Access Compliance Report Public Rights-of-Way (Curb Ramps)

Main Street: N/A Cross Street: O_NEILL_DR Location: SE

ADA ID: RPRK220223170341 Ramp Type: Type 6 - Directional 1 Initial Pass/Fail: Pass Overall Compliance: No Severity Score: 10

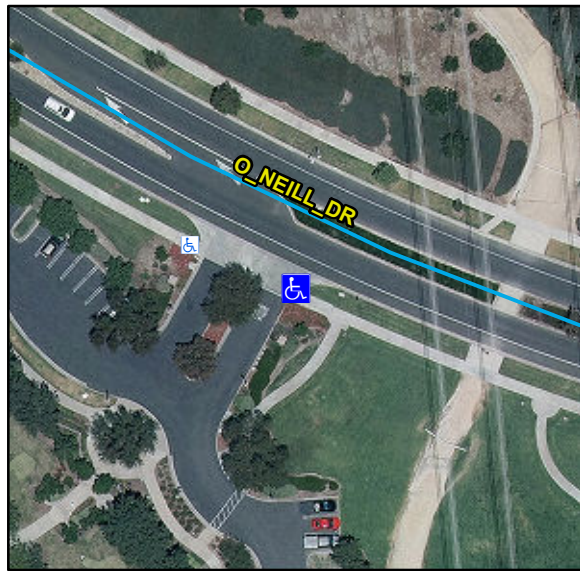
Compliance	Description	Data	Compliance	Description	Data
N/A	Ramp Length (in)	122	Yes	Flare Type LT	
Yes	Ramp Width (in)	72			Curbed2
Yes	Ramp Run Slope (%)	1.1	N/A	Flare Slope LT (%)	N/A
Yes	Ramp Cross Slope (%)	3.1	N/A	Flare Traversable LT	N/A
No	Grade Break	No	Yes	Flare Type RT	
N/A	Grade Break Slope (%)	N/A			Curbed2
N/A	Grade Break Cross Slope (%)	N/A	N/A	Flare Slope RT (%)	N/A
	Addl Para Ramp Left?	No	N/A	Flare Traversable RT	N/A
	Addl Para Ramp Right?	No	No	DWS Provided	No
N/A	Landing Present	Yes	N/A	DWS Contrast	N/A
Yes	Landing Length (in)	120	N/A	DWS Length (in)	N/A
Yes	Landing Width (in)	72	N/A	DWS Full Width	N/A
Yes	Landing Run Slope (%)	1.1		DWS Offset Type	N/A
Yes	Landing Cross Slope (%)	0.2	N/A	DWS Left Offset (in)	N/A
N/A	Landing Movement Obstructed?	No	N/A	DWS Right Offset (in)	N/A
	Landing Movement Type	N/A			
N/A	Landing Shared	No			
N/A	Marked Crosswalk 1	No	N/A	Clear Space	N/A
	Crossing 1 Direction	W	N/A	Clear Space To Crosswalk (in)	N/A

Marked Crosswalk 1 Width (in)	N/A			
N/A	Ramp Inside Crosswalk 1	N/A			
	Crossing 1 Slope (%)	0.4			
	Crossing 1 Cross Slope (%)	3.6			
Yes	Gutter Ponding	No	Yes	Curb Slope	3
Yes	Gutter Lip Height (in)	0		Road Run Slope (%)	N/A
Yes	Gutter Run Slope (%)	0.2		Road Cross Slope (%)	N/A
Yes	Gutter Cross Slope (%)	2.4		Parallel Ramp Side	N/A
Yes	Overall Surface Condition	Acceptable	Yes	Perp Joint Present	Yes
	Cross Gutter Present?	Yes		Spandrel Present?	Yes
	Replace Cross Gutter?	No		Replace Spandrel?	No

Remove & Replace Entire Ramp.
